Access Compliance Report

Public Rights-of-Way

(Curb Ramps)

Intersection ID: 4080	Main Street: DAVID_COX_RD	Cross Street: REDBRIDGE_TL	Location: NW
ADA ID: F8A7831C6FD4	Ramp Type: PerpDiag	Initial Pass/Fail: Fail	Overall Compliance: No
		Severity Score: 12.5

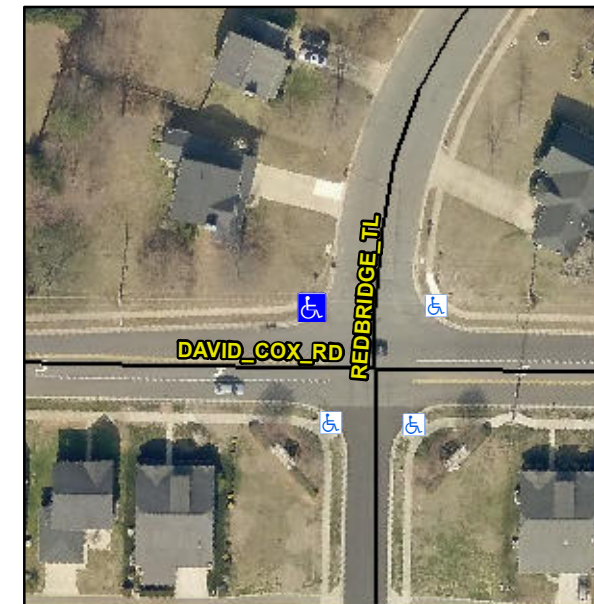
Not Found, R304.2.2

Compliance	Description	Data	Compliance	Description	Data
N/A	Ramp Length (in)	97.0	No	Ramp Slope (%)	8.5
Yes	Ramp Width (in)	48.0	Yes	Ramp XSlope (%)	0.0
N/A	Flare Type LT	N/A	N/A	Flare Type RT	N/A
N/A	Flare Slope LT (%)	N/A	N/A	Flare Slope RT (%)	N/A
N/A	Flare Traversable LT?	N/A	N/A	Flare Traversable RT?	N/A
N/A	Landing Length (in)	N/A	N/A	DWS Provided?	N/A
N/A	Landing Width (in)	N/A	N/A	DWS Contrast?	N/A
N/A	Landing Slope (%)	N/A	N/A	DWS Length (in)	N/A
N/A	Landing X Slope (%)	N/A	N/A	DWS Full Width?	N/A
N/A	Landing Curb? (Y/N)	N/A	N/A	DWS Offset (in)	N/A
N/A	Shared Landing?	N/A			
N/A	Gutter Ponding?	N/A	N/A	Gutter Slope (%)	N/A
N/A	Gutter Lip Ht (in)	N/A	N/A	Gutter X Slope (%)	N/A
N/A	Painted X Walk1?	No	N/A	Painted X Walk2?	No
	X Walk 1 Direction	To S		X Walk 2 Direction	To E
N/A	X Walk 1 Width (in)	N/A	N/A	X Walk 2 Width (in)	N/A
	X Walk 1 Slope (%)	1.3		X Walk 2 Slope (%)	3.3
	X Walk 1 X Slope (%)	1.5		X Walk 2 X Slope (%)	0.0

Remove & Replace Curb Ramp With Two New Directional Ramps or Equivalent.
